MONTGOMERY COUNTY HISTORIC PRESERVATION COMMISSION
STAFF REPORT

Address:	23345 Frederick Road, Clarksburg	Meeting Date:	5/28/2025
Resource:	Contributing Resource (Clarksburg Historic District)	Report Date:	5/21/2025
		Public Notice:	5/15/2025
Applicant:	Javier Nogales (Michal P. Rouse, Architect)	Tax Credit:	No
Review:	HAWP	Staff:	Laura DiPasquale
Case Number:	1115052		
PROPOSAL:	Porch modifications, fenestration alterations, siding replacement, and other alterations

Old Parsonage Renovation
23345 Frederick Rd. • Clarksburg, MD 20871

Historic Work Area Permit Set

Figure 9: Existing southeast side elevation.

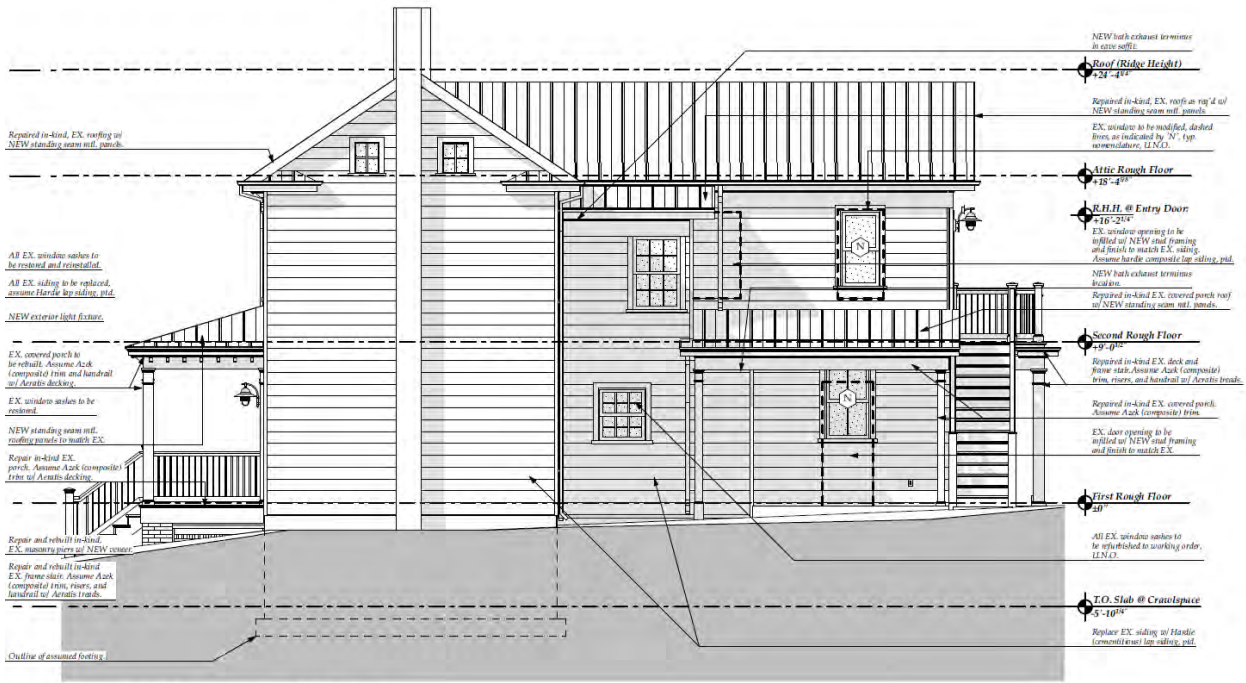
As with the front porch, staff finds that the existing side/rear porch, stair and landing are not original, having replaced a two-story side porch visible in the 1913 photograph, so staff finds that an exact replication of the earlier feature is not necessary, but that the proposal should be compatible with the character of the property, per Chapter 24A-8(b)(2) and *Standard 9*. As with the front porch, staff recommends that the details of the rear porch, stair, and landing railing be simplified to be more in keeping with the vernacular character of the I-house style building and to avoid creating a false sense of history, per the *Standards*. Staff recommends that all posts be approximately 4-inches square, and that the landing posts replicate the simple style of the proposed rear stair railing newel posts. Staff notes that the first-floor rear posts supporting the landing above are not dimensioned, but should likewise be 4-inches square, if structurally sufficient, or a maximum 6-inches square, with no ornamentation. Staff finds that the proposed Azek trim and posts and TimberTech railings should be replaced with wood, per Chapter 24A-8(b)(2), but that the proposed Aeratis porch flooring and stair treads are consistent with *Policy No. 24-01*.

2. The rear landing support columns must be simplified square wood posts and the minimum size required by Code.
3. The front porch flooring must be run perpendicular to the façade.

Figure 12: Existing rear elevation drawing.

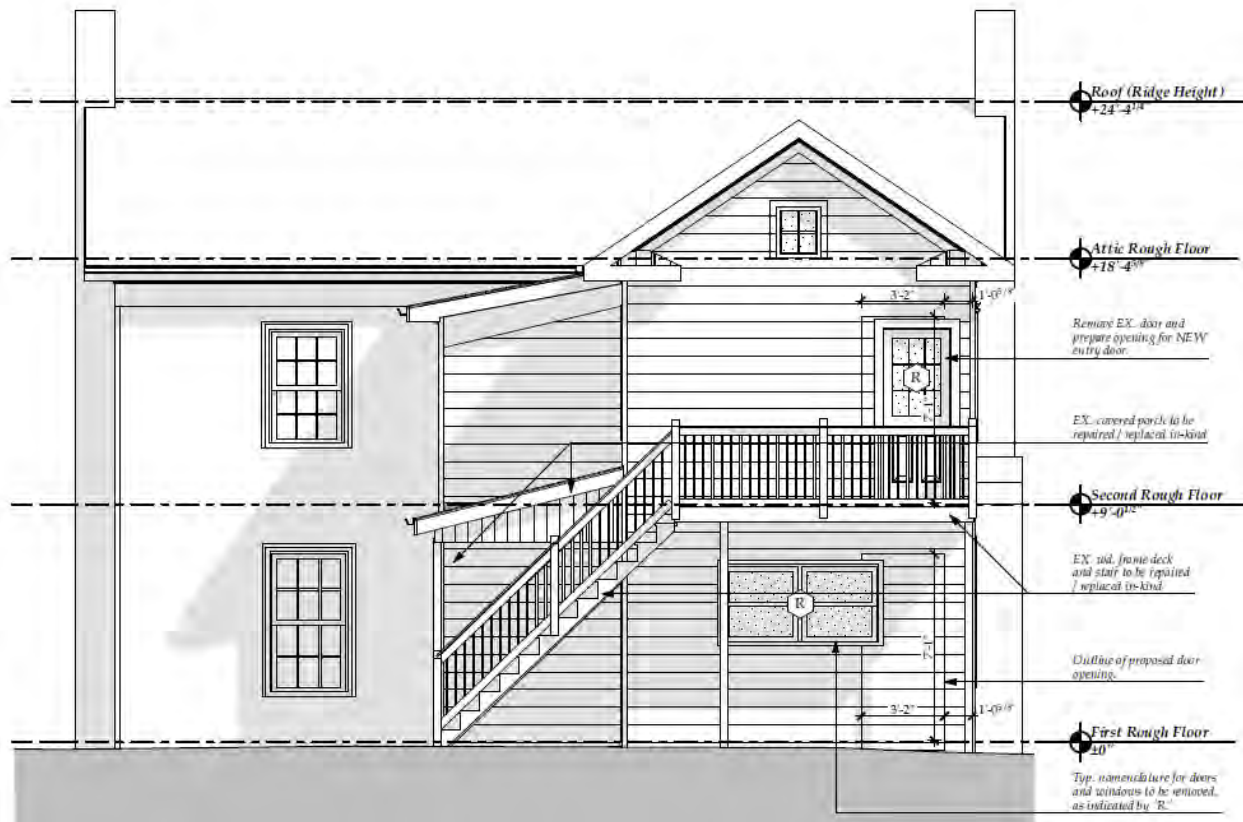
Figure 13: Proposed rear elevation. The posts on the 2nd-floor landing should replicate the simple square appearance of the newel posts at the base of the stair (outlined in red), and the ornamentation removed from the landing support columns.

Figure 18: Detail of the proposed side elevation of the rear ell and proposed window details.

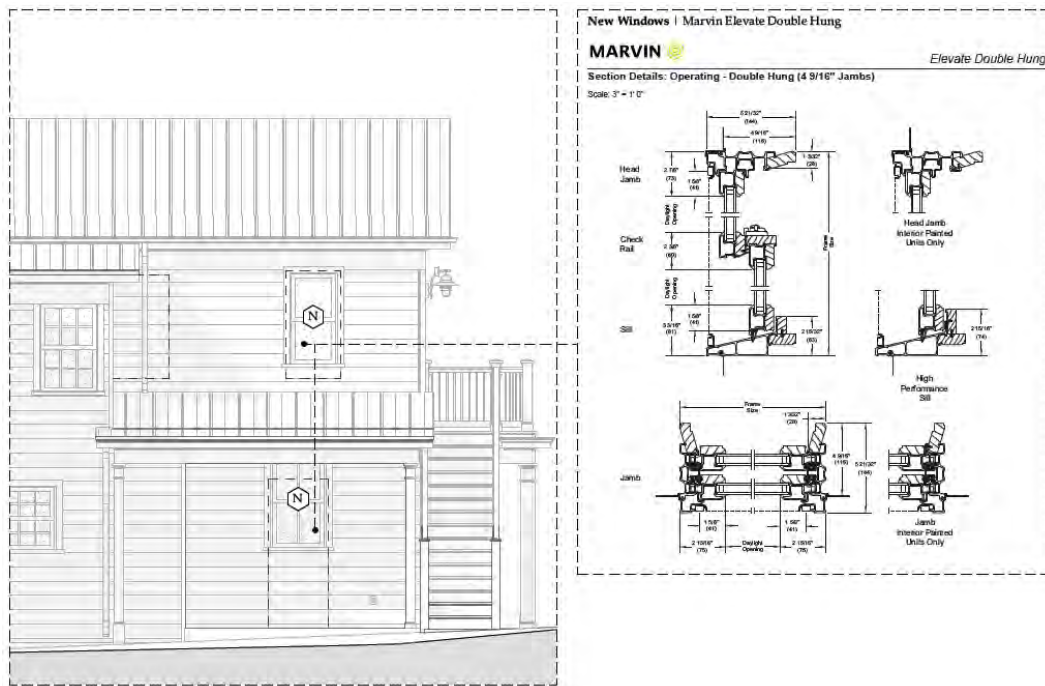
On the southeast side elevation of the rear ell, the applicants propose to remove the existing first-floor door and two existing second-floor windows, and on the northeast rear elevation of the ell, the applicants propose to remove a set of first-floor windows and a second-floor door. On the rear elevation of the ell, the applicants propose to modify a non-historic first-floor window opening and to replace an existing wood door with two new wood doors. The *Secretary of the Interior's Rehabilitation Guidelines* recommend “adding new window openings on rear or other secondary, less visible elevations, if required by a new use. The new openings and the windows in them should be compatible with the overall design of the building but, in most cases, not duplicate the historic fenestration.” Staff finds that the proposed locations are minimally visible from the public right-of-way and would meet these guidelines, as well as Chapter 24A-8(b)(1). Staff finds that the proposed Marvin Elevate fiberglass windows and ¾-lite wood doors have traditional profiles that would be generally compatible with the historic resource, per *Standard* 9, but that wood windows would be the appropriate compatible material for use on the historic ell, per Chapter 24A-8(b)(2). As currently presented, the application proposes a two-over-two window at the first floor and one-over-one window at the second floor. Staff recommends that both new windows have the same configuration, either one-over-one or two-over-two.

4. The proposed windows on the southeast side elevation must be wood and both be the same configuration with either one-over-one or two-over-two simulated-divided-lites.

Figure 20: Proposed siding material.

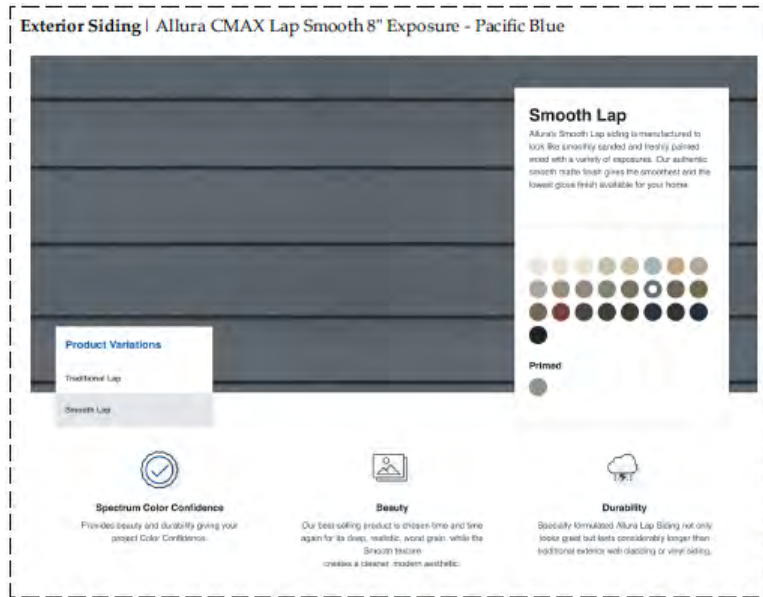
The applicants propose to replace the existing wood-textured aluminum siding with smooth 8-inch exposure fiber cement siding. Staff finds that the aluminum siding predates designation, but that it appears to cover the original wood Dutch lap siding with a narrower, approximately 5-inch exposure, which is visible on the front façade where the porch fascia was recently removed. Staff finds that the removal of the aluminum siding and restoration or in-kind replacement of the wood Dutch lap siding to match the dimensions, texture, profile and appearance of the historic wood siding would be the appropriate treatment, per *Standard 6* and Chapter 24A-8(b)(2). The restoration of the historic siding would be eligible for the County historic preservation tax credit.

5. The original wood siding must be repaired or replaced in-kind with 5-inch exposure Dutch lap wood siding.
6. The standing-seam metal roofing must have maximum 1-inch seams, 1-inch crimped ridge caps, and 18 to 20-inch exposure. The applicant must provide detailed photographs of the existing roofing to the Historic Preservation Office for the property file. The applicant is encouraged, but not required, to provide a small physical sample of the roofing to the Historic Preservation Office for its archive.

Figure 23: Detail of the roofing on the rear ell.

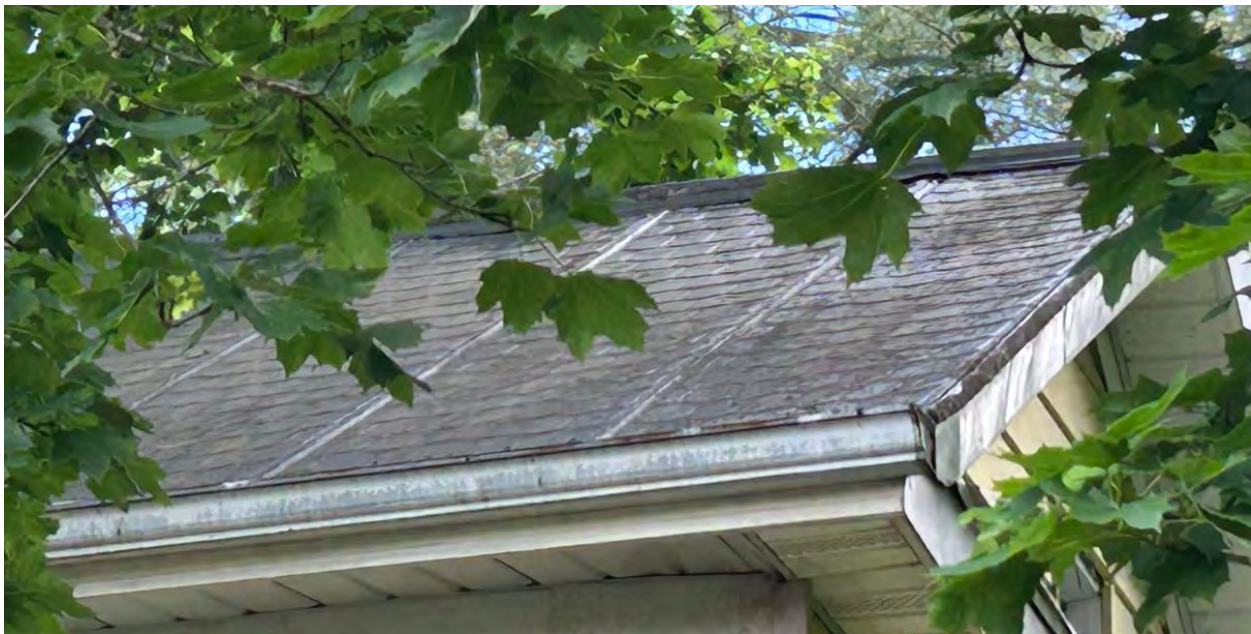
The applicants propose to replace the existing roofing with new McElroy Metals 138T Galvalume Standing Seam roofing with 1.375-inch seams and 16-inch exposure. Staff finds that the existing roofing is unusual and appears to be low-profile standing-seam metal panels embossed with a shingle pattern, seemingly a hybrid of the standing-seam metal roofing and pressed metal shingles popular throughout the country by the late nineteenth century. The roof has 17 panels across the approximately 34-foot wide main roof. Staff is unfamiliar with any other properties with this particular roofing type and it does not appear to be commercially available. Staff finds that the roofing shows evidence of rust and extreme wear, and that, if original to the building, or dating to between the late-nineteenth and early-twentieth centuries, the material is over 100 years old and has likely long exceeded its predicted service life. As such, staff finds that the severity of deterioration warrants replacement, per *Standard 6*, but that an in-kind replacement would be extremely difficult and recommends approval of a compatible roofing material. The *Vision of Clarksburg* notes that the district includes many asphalt shingle replacement roofs, but that numerous properties retain their original standing-seam metal roofs. Staff recommends that a low-profile standing-seam metal roof with maximum 1-inch seams and 18 to 20-inch exposure to more closely replicate the dimensions of the existing roofing would be most appropriate for the replacement roofing. Staff recommends the HPC condition the replacement on the applicants providing detailed photographic documentation of the roofing and encourage the applicants to donate a small section of the roof to the Historic Preservation Office for future reference.

Figure 26: Proposed basement plan.

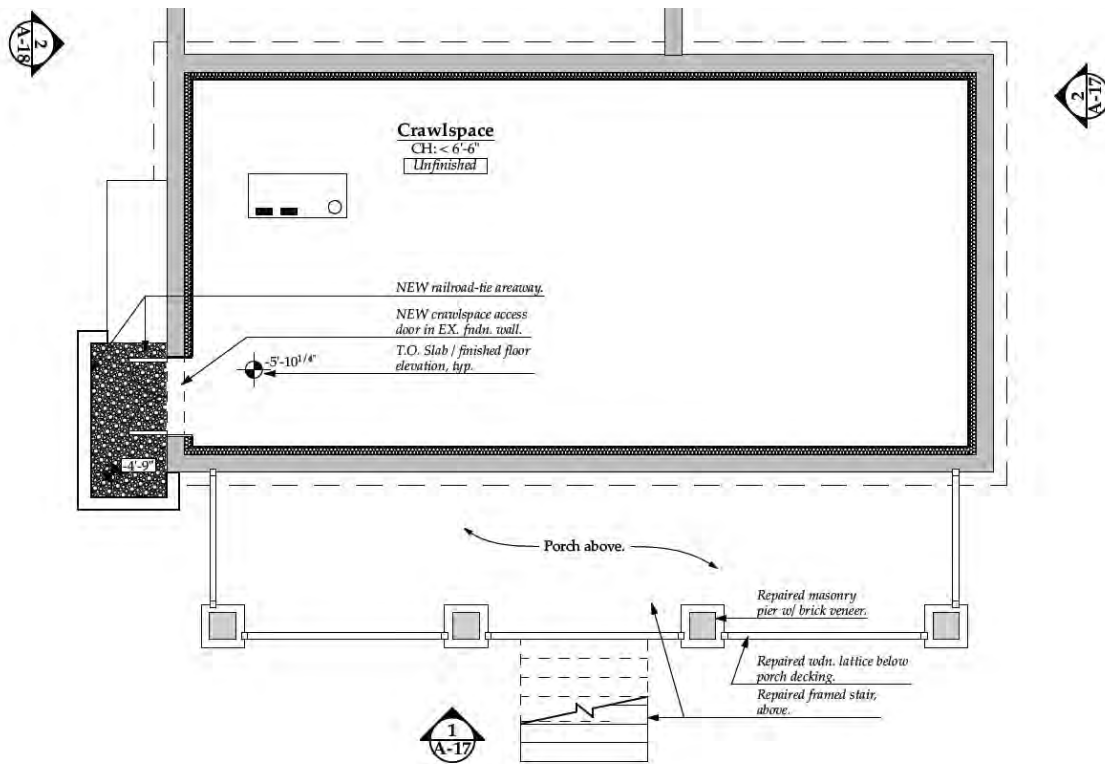
Along the northwest side elevation, visible from Frederick Road and Spire Street, the applicants propose to cut a new set of doors in the foundation wall, accessed by a new areaway enclosed by a timber retaining wall, and to install a new concrete pad and condensing unit enclosure. Staff finds that, although the equipment enclosure will be visible from the public right-of-way, the proposed location is along a secondary elevation and would not obscure or damage any historic materials or character-defining features of the property, per *Standard 2*. The applicants also propose to install two new vents on the rear elevation, which staff finds will not substantially alter the exterior features of the resource, per Chapter 24A-8(b)(1).

7. The applicant must provide an elevation detail of the modified foundation wall at the proposed areaway, including the proposed egress door.
